**Re: Western Parkland City Authority Request to be a Master Planner for
the Bradfield City Centre**

Master Plan Request

Re: Bradfield City Centre Master Plan Request – Response to Request for Additional
Information

Addendum to Master Plan Request

Sepp Land Reservation Acquisition Map overlaid with the Bradfield City Centre Master Plan

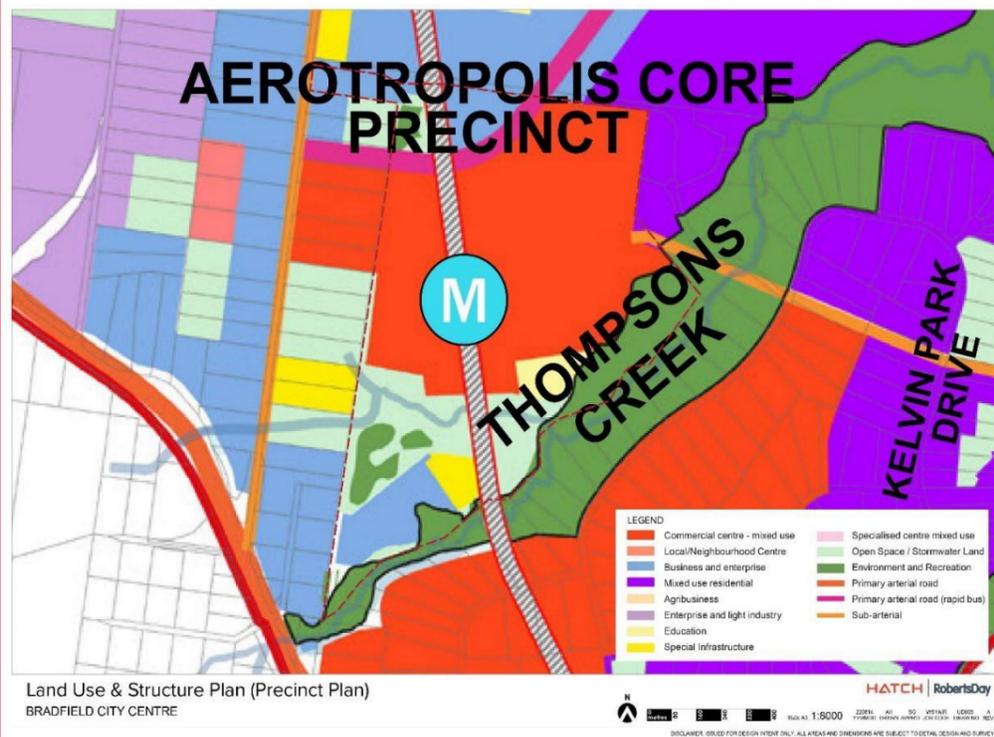
3.1	Open space needs to be confirmed rather than indicative. Is the MP consistent with the Precinct Plan and SEPP – why / why not? Some sentences state that it is, and others suggest that it will change. Needs to be clearer.	The proposed Open Space is consistent with the SEPP and Precinct Plan. Approximately 38 hectares of open space will be provided which equates to 33% of the site. The proposed total provision of open space on site will allow for the Bradfield City Centre to comply with the relevant requirements for landscaping and deep soil provision at the subdivision and detailed development application stages. The Bradfield City Centre Master Plan has also allocated sufficient Open Space for the purposes of biodiversity conservation and for meeting the targets of 40% tree canopy cover across the Aerotropolis consistent with the Precinct Plan.

3.2	How are WPCA treating open space and stormwater land – dedication to council / Sydney Water or ongoing management? Needs more detail.	On-going management of open space and stormwater assets shown on the master plan will be discussed with DPE and the relevant acquisition authorities through the TAP process and as the master plan is finalised prior to submission.

The proposed master plan does not seek to change the SEPP Land Reservation Acquisition Map. WPCA will continue to consultation with DPE and Sydney Water as further information on stormwater becomes available.

This is a high level indicative open space plan. The area location and size of the open space will be discussed during the TAP process. The nomination of the acquisition authority and process for the proposed open space will be the same process that WPCA and DPE need to go through to identify the land Reservation Acquisition map under the Parkland SEPP.

The ownership of the proposed open space would be subject to ongoing discussions prior to the submission of the master plan.

Precinct Plan Land Use & Structure Plan overlaid with Bradfield City Centre

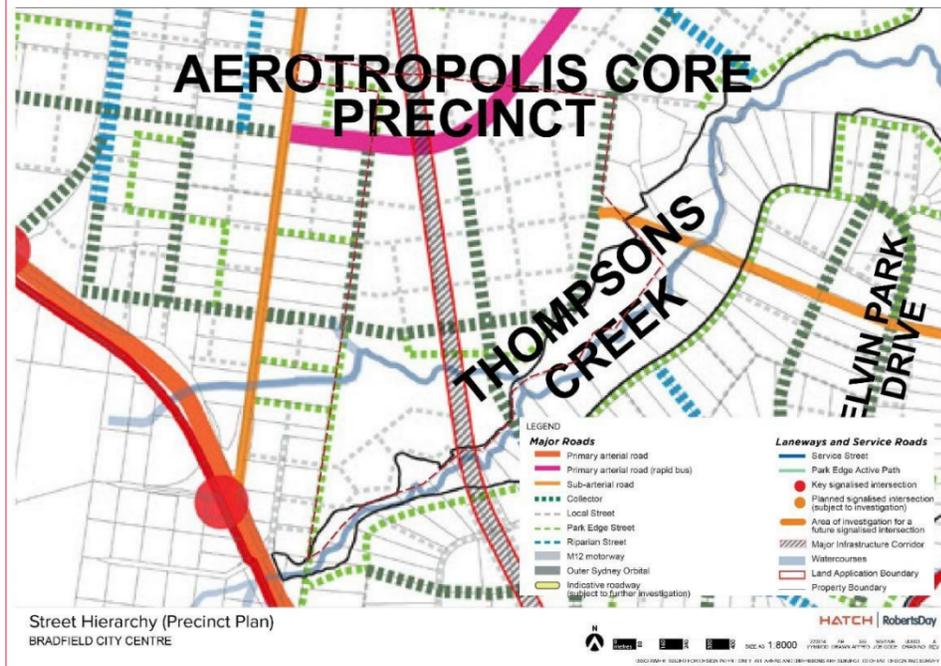
1.7	Need visual comparisons between Precinct Plan maps and proposed structure plan / intended master plan outcomes. These were included in the presentation and should also be in the Master Plan Request	The Presentation outlining the visual comparisons between Precinct Plan maps and proposed structure plan is provided in Appendix 1 .

The Precinct Plan Land Use and Master Plan overlaid with the Bradfield City Centre Structure Plan indicates that it is generally consistent with the Precinct Plan.

No major amendments and deviations are proposed at this stage in the Master Planning Process to the Precinct Plan Maps.

If there are any potential minor amendments to the maps as part of the master planning process, they will be discussed during the TAP process.

Precinct Plan Blue-Green Infrastructure Framework overlayed with Bradfield City Centre Master Plan

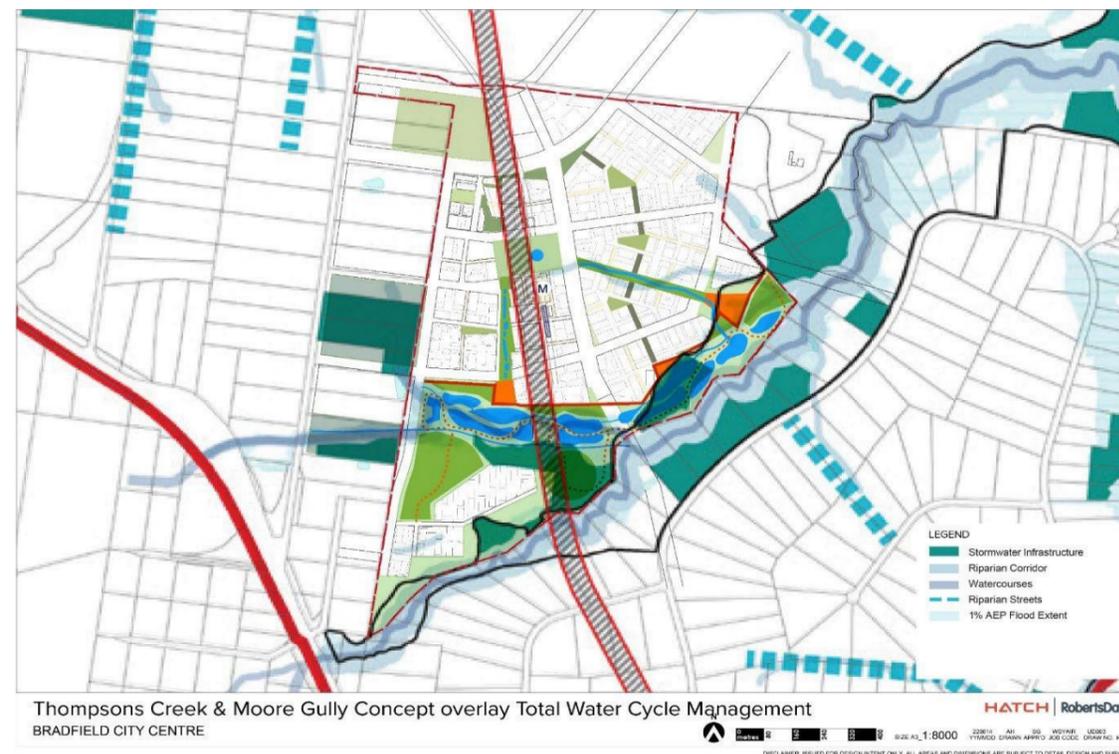
2.1	Is a public domain / landscape strategy being prepared as part of the urban design work – connection to Thompsons Creek park and broader Blue-Green framework very important.	<p>A Public Domain and Landscape Strategy has been developed and it forms part of Urban Design documentation. The strategy responds to the relevant State and Aerotropolis policies, objectives and requirements.</p> <p>The Bradfield City Centre will contribute to the establishment of the blue-green framework for the Aerotropolis. Thompsons Creek is the natural spine of the blue-green infrastructure system in Bradfield City Centre and provides a major component of the framework. The Master Plan adopts the landscape led approach with a focus on restoring, regenerating, and improving ecological and hydrological systems, with an integrated stormwater management system. The Public Domain and Landscape Strategy will improve the biodiversity and waterway health through a series of distinct spaces to link the ridge to the creek, restoring riparian corridors, and increasing canopy and green cover.</p>

The Precinct Plan Blue-Green Infrastructure Framework overlayed with Bradfield City Centre Master Plan indicates it is generally consistent with the Precinct Plan.

Bradfield City Centre will contribute to the establishment of the blue-green infrastructure network

No major amendments and deviations are proposed at this stage in the Master Planning Process.

Any potential minor amendments to the maps as part of the master planning process will be discussed during the TAP process.
